RE: LORAIN COUNTY
BLACK RIVER BASIN
CITY OF LORAIN
WHITTIER MIDDLE SCHOOL

NOTICE OF DEFICIENCY

Figure 2. The temporary outlet structure for the sediment basin has not been installed.

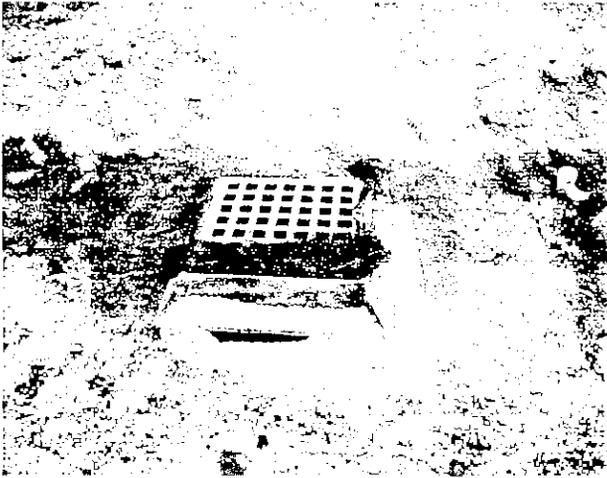
- The sediment basin has been completed (Figure 1), however, the temporary outlet structure has not been installed. A piece of filter fabric was observed to be placed over the outlet structure for sediment control (Figure 2). Remove the filter fabric and immediately install the temporary riser pipe in accordance with the site's storm water pollution prevention plan (SWP3).
